Subject: Carrizo Energy Solar Farm (07-AFC-8)
Response to Public Advisory Regarding Continually Unanswered
Questions & Concerns from CEC & Applicant

URS Report dated 12-12-08 – Applicants Comments on PSA.

Attachment 1

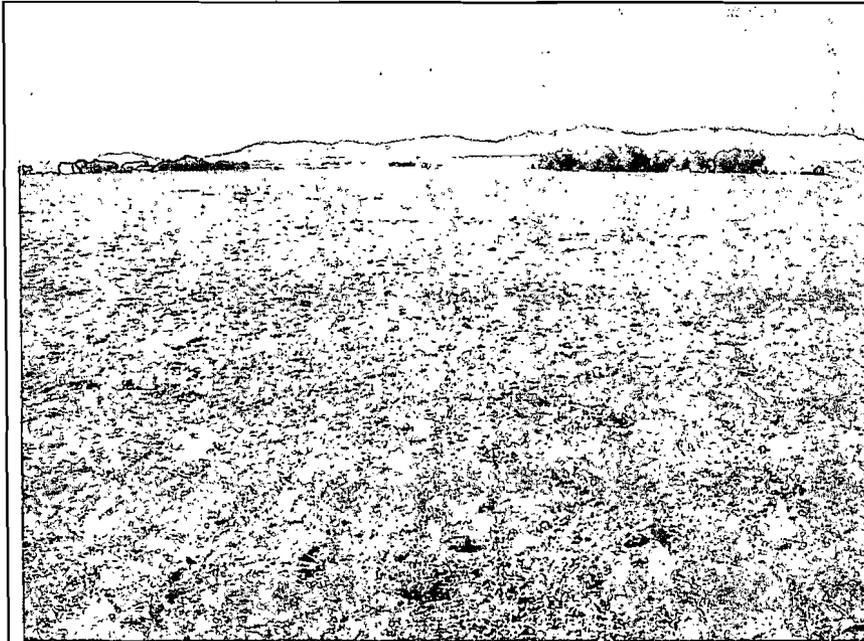
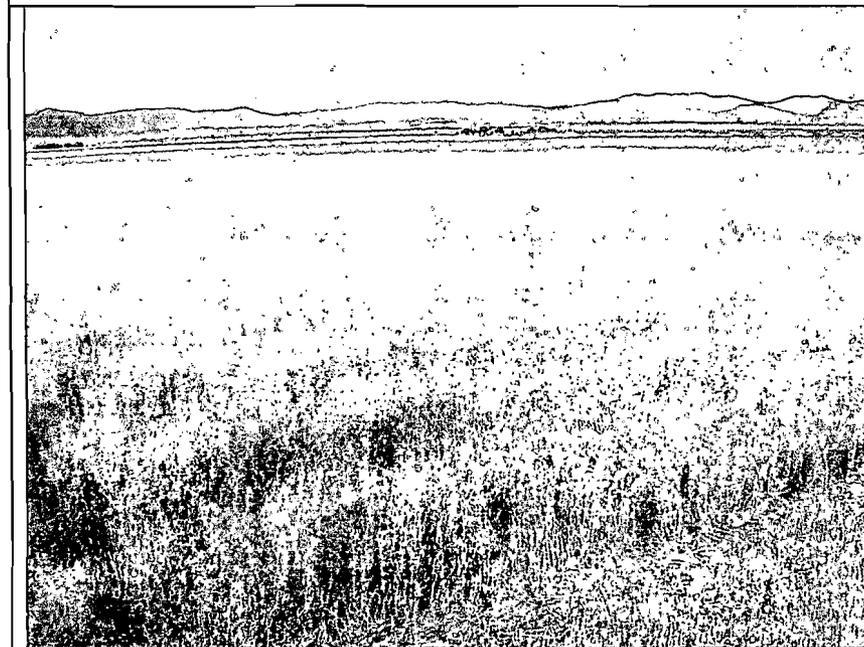
- This statement is not even close to being true. The landowner had no contact with carrot producers. Plus, the landowner only owns a garden tractor. Not only that, this site was last disked the year that the Lewis’s purchased the land when Kunhle’s had a grain crop planted on it. (see attachment 1, 2, & 3)

SITE PLAN
CARRIZO ENERGY SOLAR FARM (CESF)

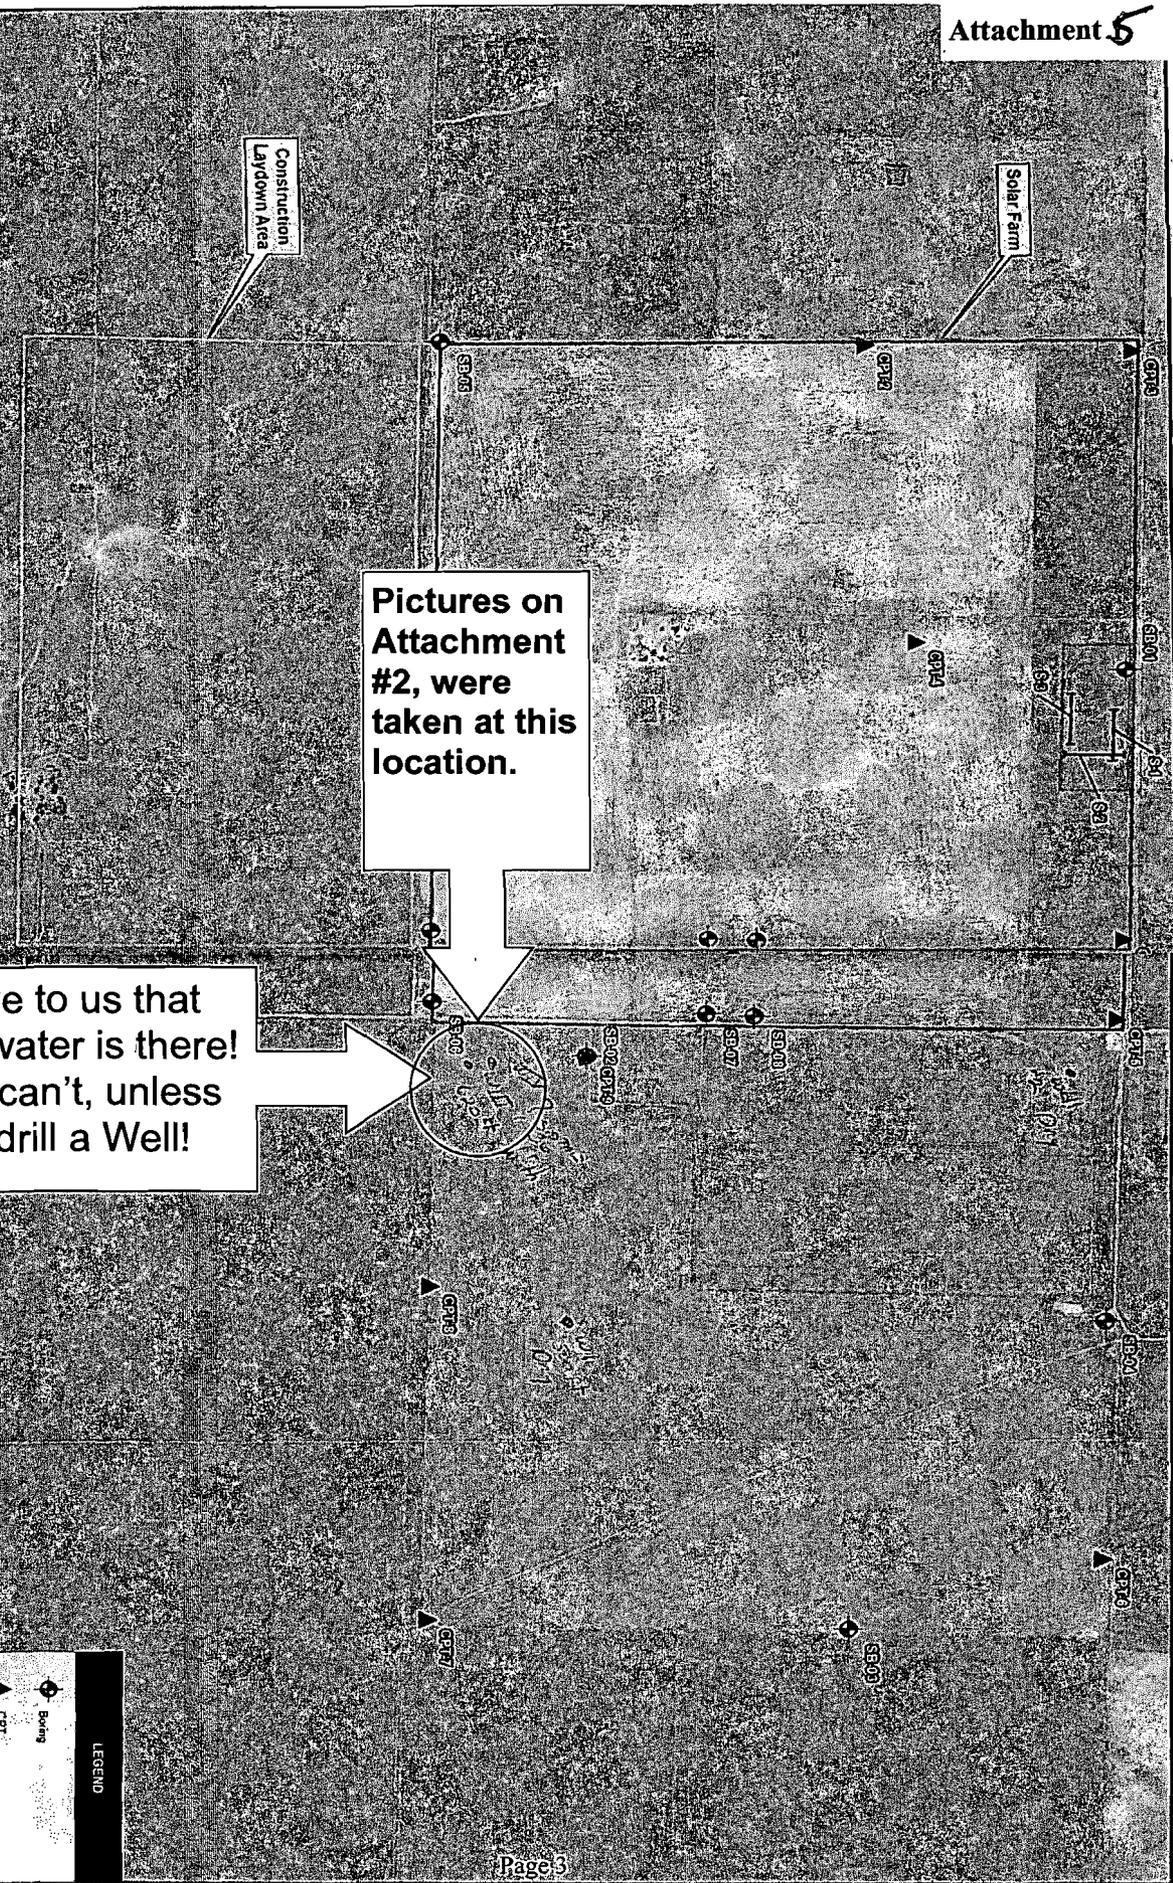
Pictures on Attachment #2, were taken at this location.

Prove to us that the water is there! You can't, unless you drill a Well!

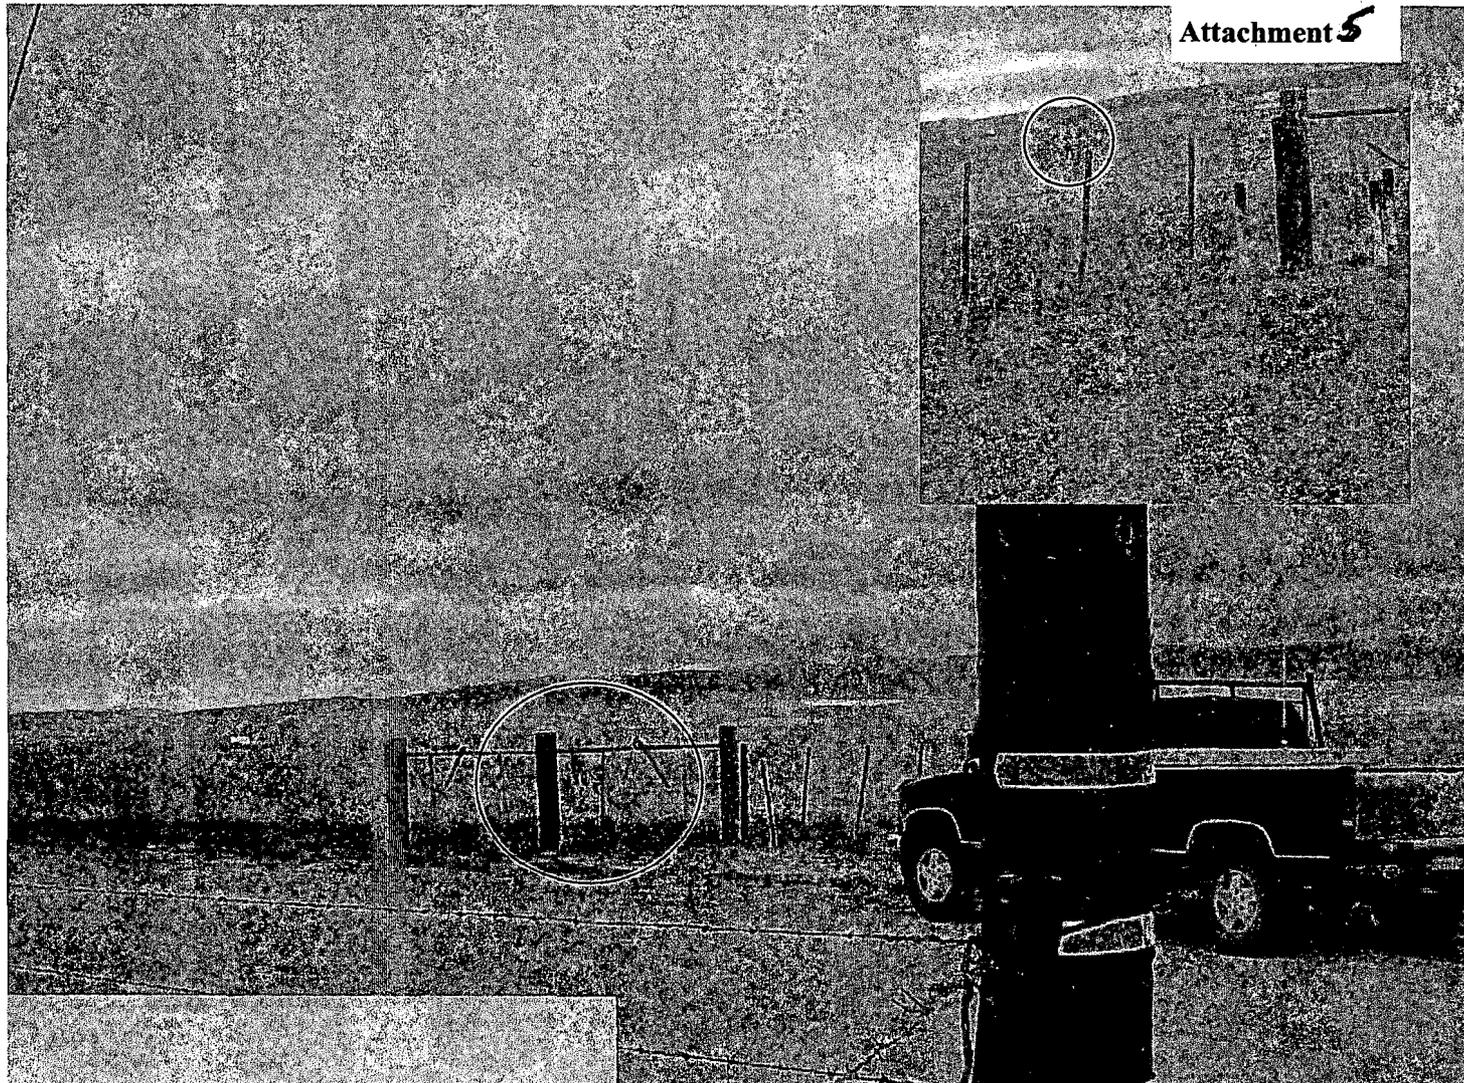
Picture taken 1-3-09 at the Acro Site, at the corner Hwy 58 and Tracey Lane Trail. Where John is standing is the exact measured spot where Asura's Water Report shows that there is a 620 foot deep Well. This is the same Well that CEC is basing it's decisions on.

WHERE'S THE WELL???

Location: 035° 18' 58.3" N 120° 00' 09.6" W
 Caption: FIGURE 2

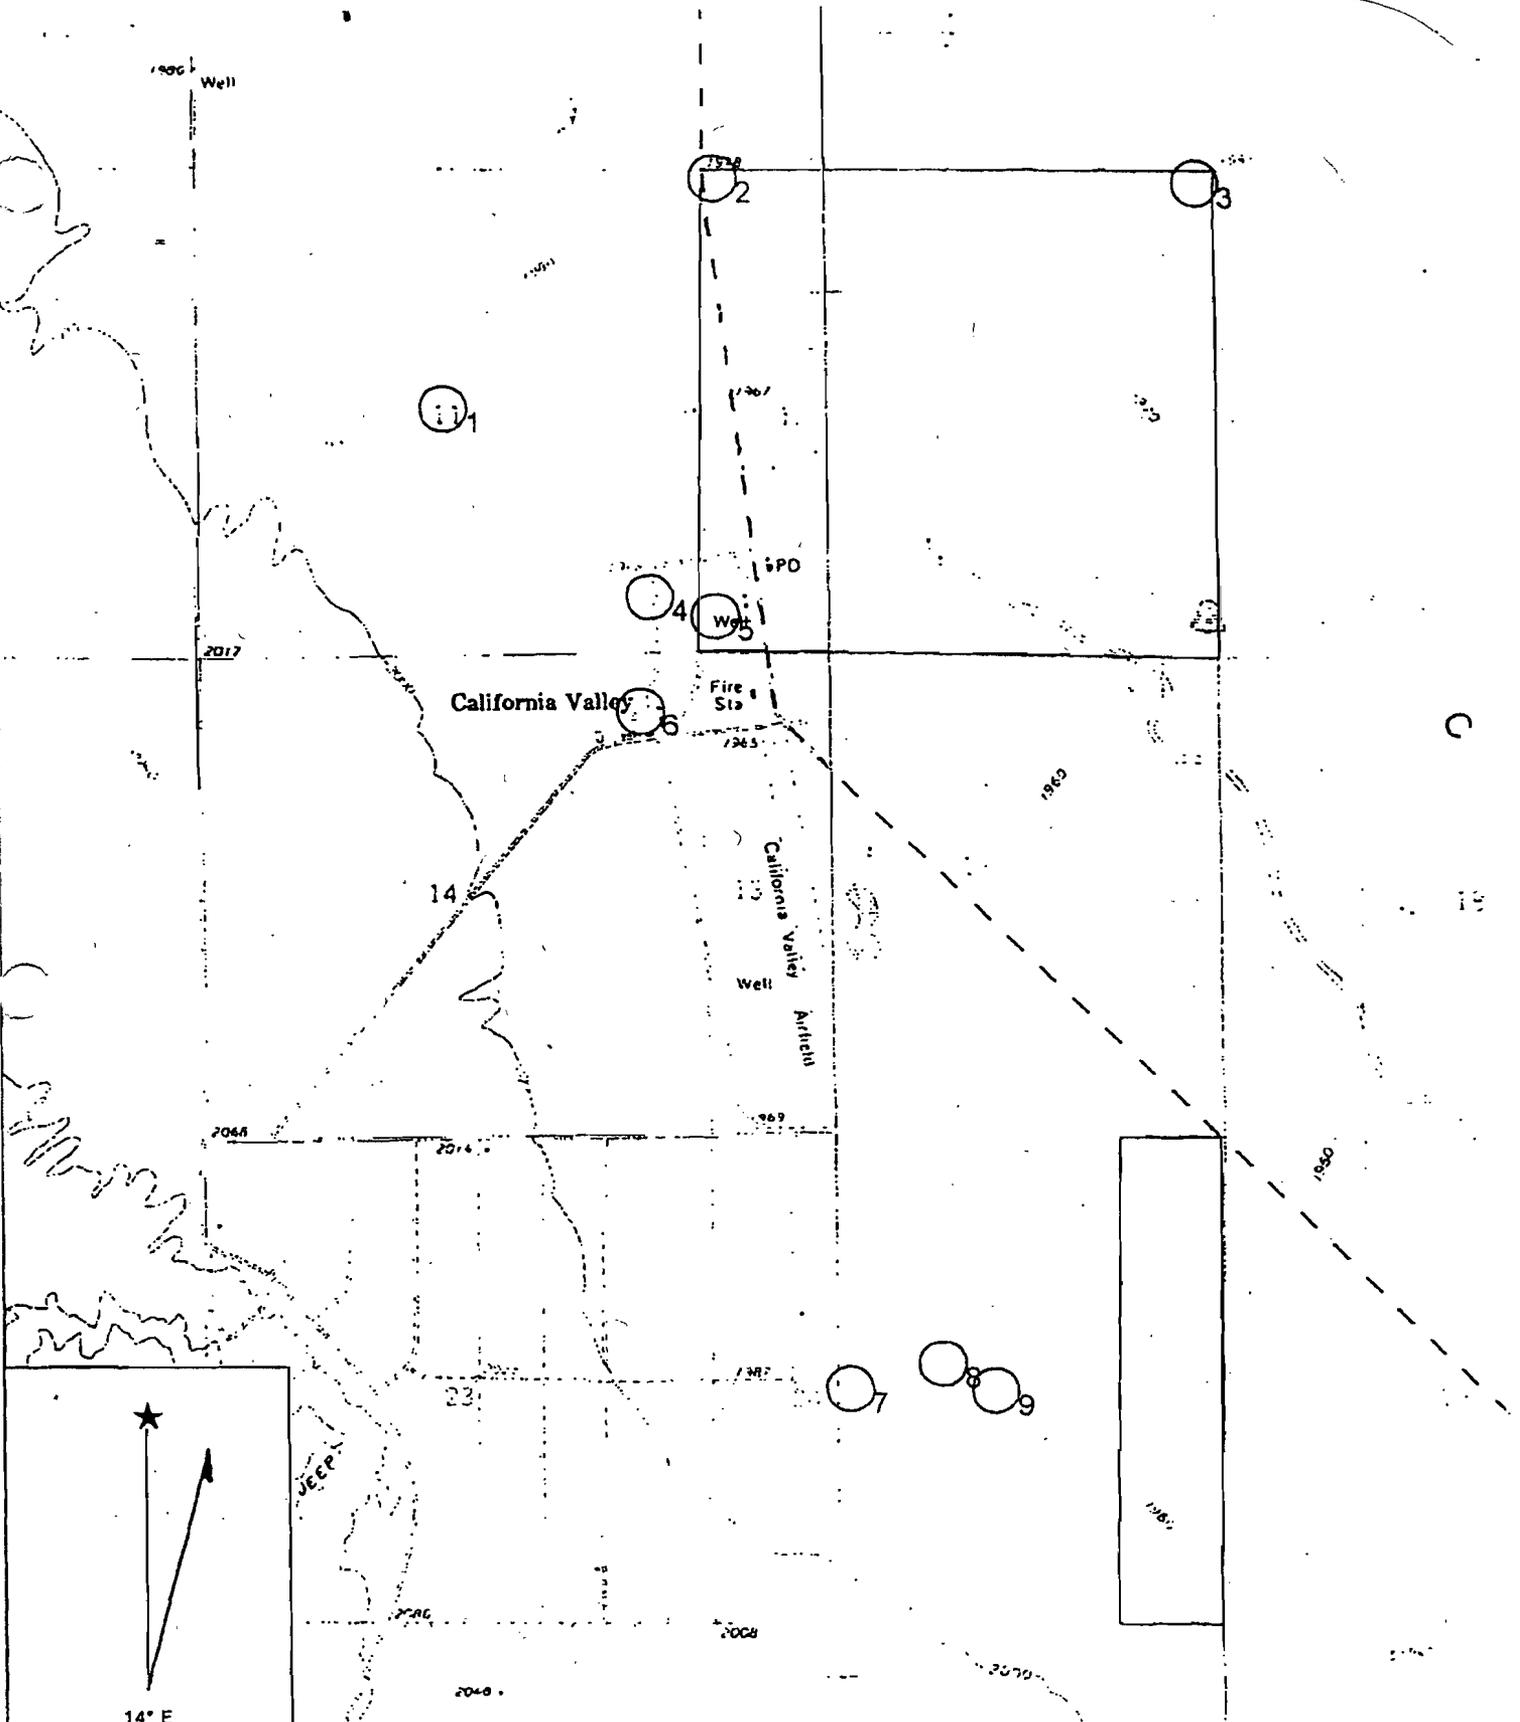
*this boring did not happen on my
land*
